WATER PERMIT NO. 7421-3

**RECOMMENDATION OF CHIEF ENGINEER FOR WATER PERMIT
APPLICATION NO. 7421-3, Valley View Farms, Inc.**

REPORT TO THE CHIEF ENGINEER
ON
WATER PERMIT APPLICATION NO.7421-3
VALLEY VIEW FARMS, INC.
NOVEMBER 9, 2012

Figure 1- Hydrograph of DENR-Water Rights' observation well CD-57B (Water Rights, 2012a)

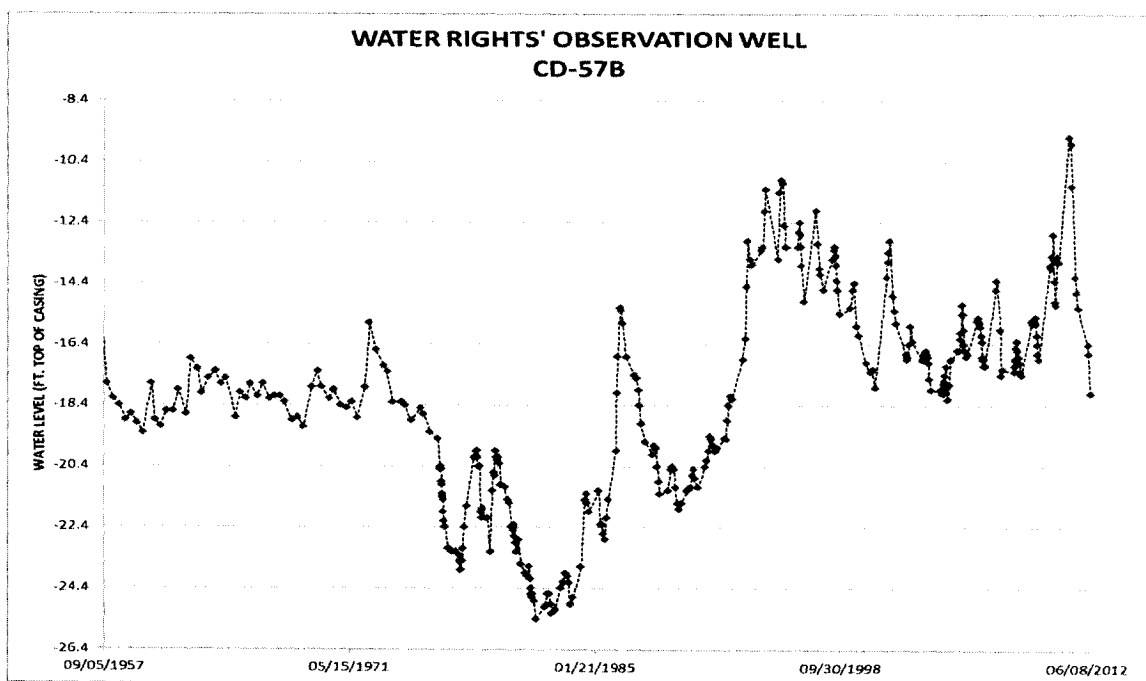
Administrative Rule of South Dakota Section 74:02:05:07 requires that “the Water Management Board shall rely upon the record of observation well measurements to determine that the quantity of water withdrawn annually from the aquifer does not exceed the estimated average annual recharge of the aquifer.”

The DENR-Water Rights Program monitors 27 observation wells completed into the Big Sioux: North aquifer (Water Rights, 2012a). The nearest of the observation well, CD-57B, is 1.1 miles northwest of the proposed well location. The water level in the observation well shows good response to climatic conditions. In general, the hydrograph of the observation well documents that there is more water in storage now than in the past. The water level rises (recharge) during wet years and gradually declines during dry years. The observation well shows the effects of pumping, but it does not appear to be adverse over the period of record. The climatic effects on water level greatly mask the temporal impacts of well withdrawal. Therefore, recharge to and natural discharge from the Big Sioux: North aquifer significantly exceeds pumping. Figure 1 shows the hydrograph for CD-57B.

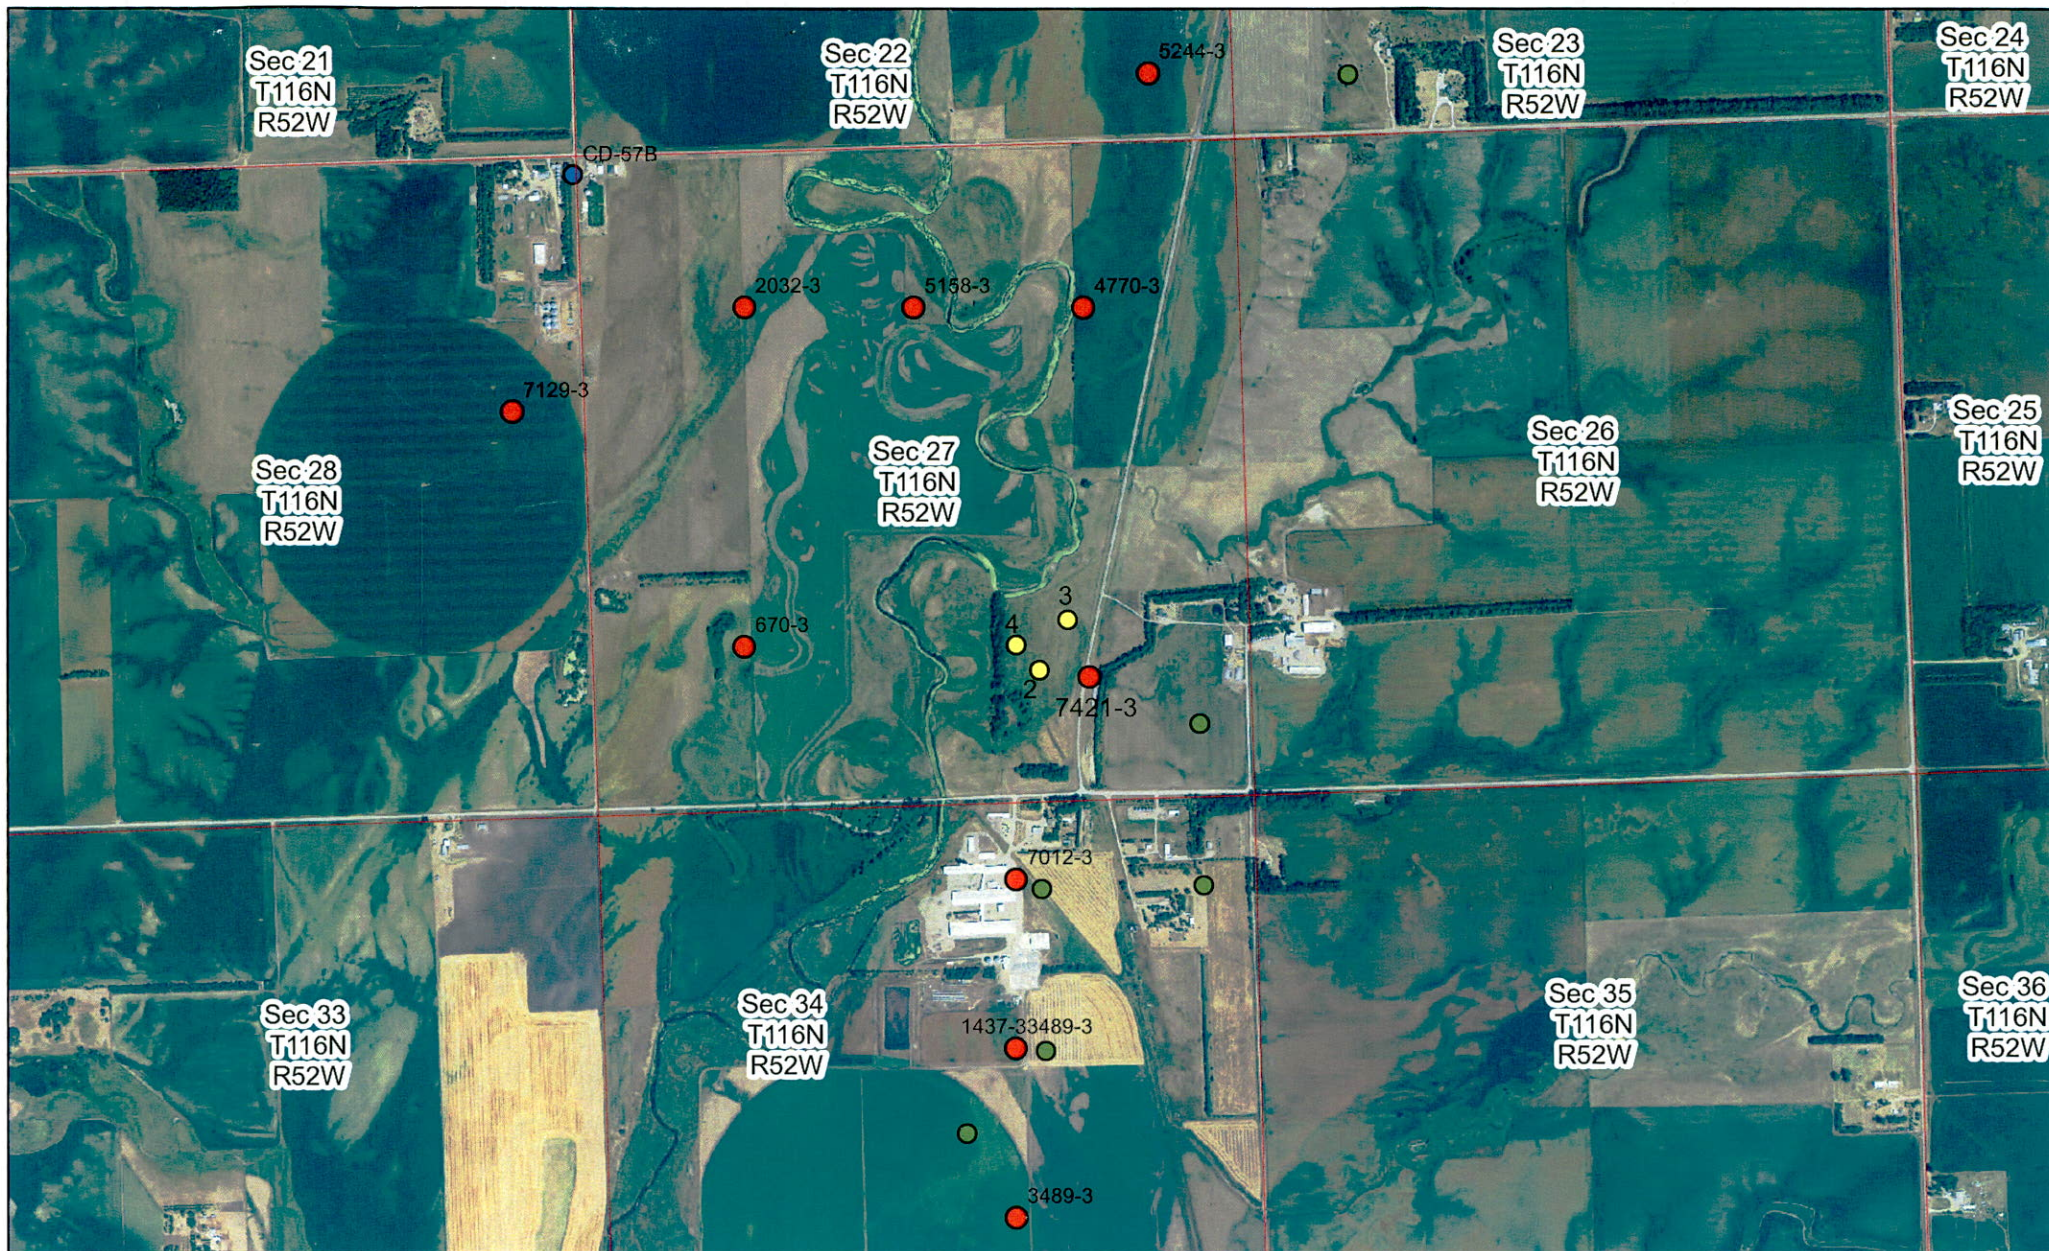
Tom Reichling (president of Valley View Farms, Inc.) has requested to add three additional wells in the S ½ SE ¼ of Sec 27, T116N, R52W. The basis for this request is that the existing well only provides approximately 250 gallons per minute (GPM) of the permitted 900 GPM. The three additional wells have already been completed with depths and flow rates as follows: Well 2 has been completed to a depth of 27 feet and provides approximately 200 GPM. Well 3 has been completed to a depth of 30 feet and provides approximately 300 GPM. Well 4 has been completed to a depth of 27 feet and provides approximately 150 GPM. See attached map for well locations.

The Chief Engineer makes a finding pursuant to SDCL 46-5-13.1 and ARSD 74:02:01:14:01 that:

These additional diversion points do not increase the potential for adverse effects to existing diversions.
